Fire Suppression Services Incorporated 3802 South 2300 East, Millcreek, UT 84109. Ph (801) 277-6464

#### Heritage Garden Care center

These were observed 2019-08-29

#### New addition to Antifreeze system

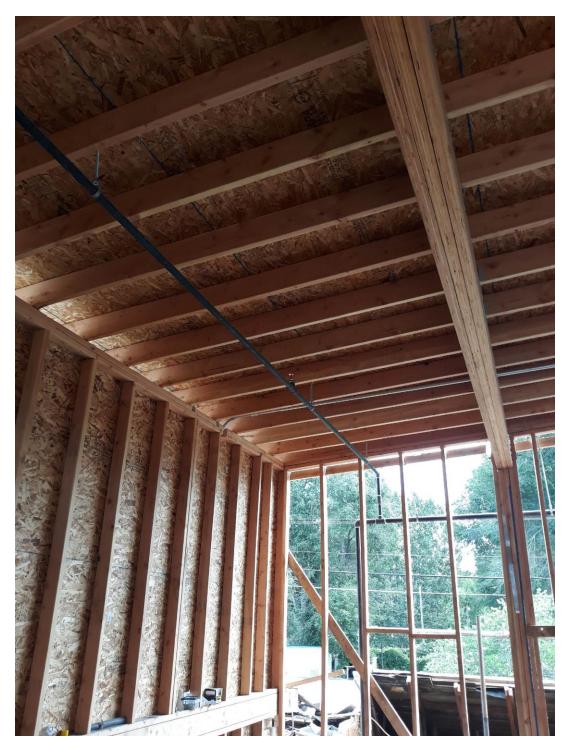
Antifreeze system has had additions to it. 2022 limit per State Fire Marshal, along with: this is a Care Center, will prohibit the permissibility of an extension. Additions and alterations to this building may require site brought up to current Code.
